Access Compliance Report

Public Rights-of-Way

Intersection ID: 53456	Main Street: OYSTER_LN	Cross Street: EASTFIELD_RD	Location:	N
ADA ID: 201B877FF3ED	Ramp Type: Perp	Initial Pass/Fail: Pass	Overall Compliance: No	Severity Score: 5

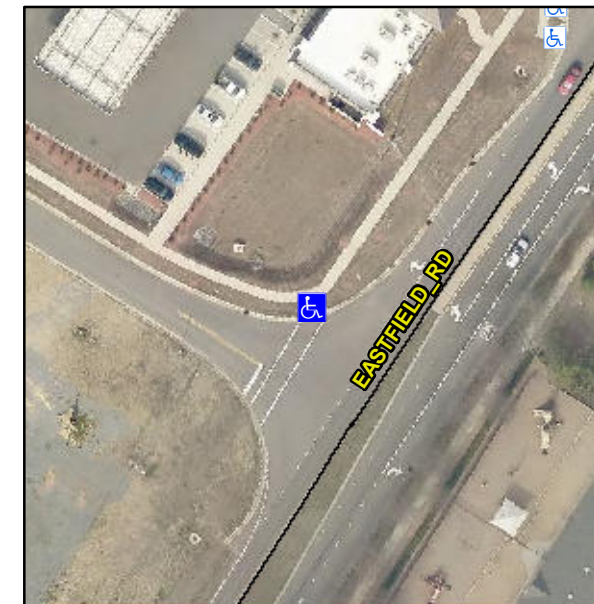
**Not Found, R304.2.2-Perp, R304.3.2-
Para, R305.2, R304.5.4**

**Remove & Replace Entire Ramp.
Remove & Replace Gutter.**
